Title: Hwy 24:04/Hwy 817:02 Accommodations for Oversize Vehicles at Roundabout and Reclassification of Existing Highway 24:04

Memorandum (or Approval) Date: August 10, 2012

Design Exception Request Date: June 29, 2012

Highway 24 Realignment Location Plan

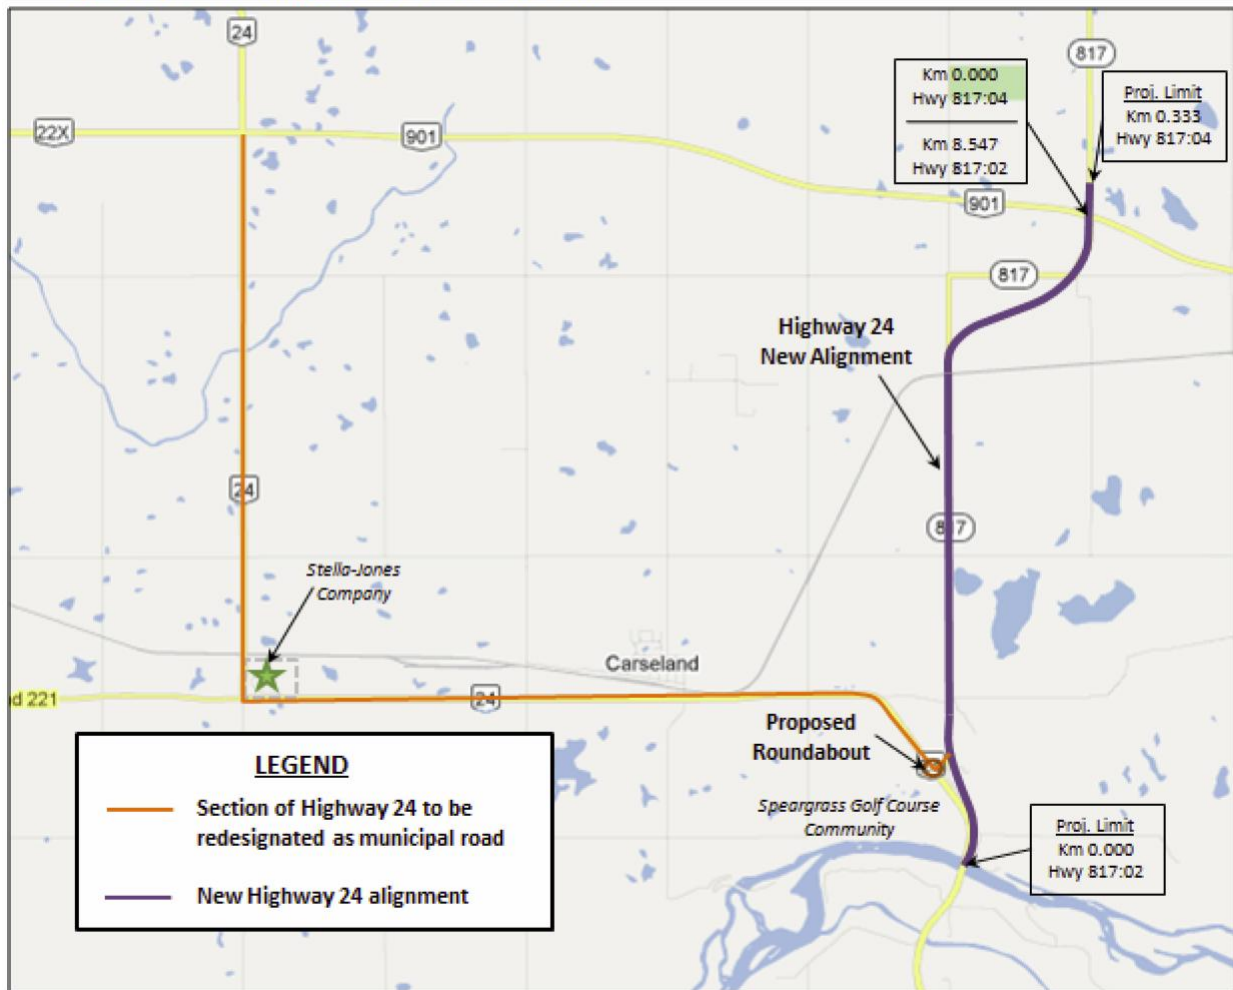
Summary
<p>The following design exception request is for the following: The existing section of Highway 24:04 (Km 2 to Km 16) from the existing Junction Highway 817 to the Junction Highway 1 will be reclassified as a local municipal road under the jurisdiction of Wheatland County. Existing alignment Hwy 817:02 will be renamed as Hwy 24 in the future.</p> <p>Design Bulletin 68/2010 (Draft October 2011) stipulates oversize vehicles (Heavy Hauler, Platform Trailer and the Reactor Transporter) shall be accommodated for all movements through the roundabout. The request is for exclusion of accommodating all three oversize vehicles for all movements at the proposed roundabout located at Hwy 24:04 and Speargrass Golf Course Community access.</p>

Rationale for Approval/Rejection
<ul style="list-style-type: none"> The proposed roundabout is located on the municipal road under the jurisdiction of Wheatland County. The single lane roundabout will accommodate design vehicles WB-21 and WB-23 for all movements. Existing Highway 24:04 from the Jct. 817 to Hwy 1 is currently designated as a proposed High Load Corridor (HLC). Refer to HLC map on the AT website on July 4, 2012 (attached). The proposed roundabout on the reclassified segment of Hwy. 24:04 (future municipal road) is acceptable to TSS - Transport Engineering provided that there will be no road bans with respect to the pavement structure on the proposed new HLC in the future. The proposed new HLC will be via existing Hwy 817 to Hwy 1

Additional Mitigation Required
No road bans with respect to the pavement structure on the proposed new HLC in the future.
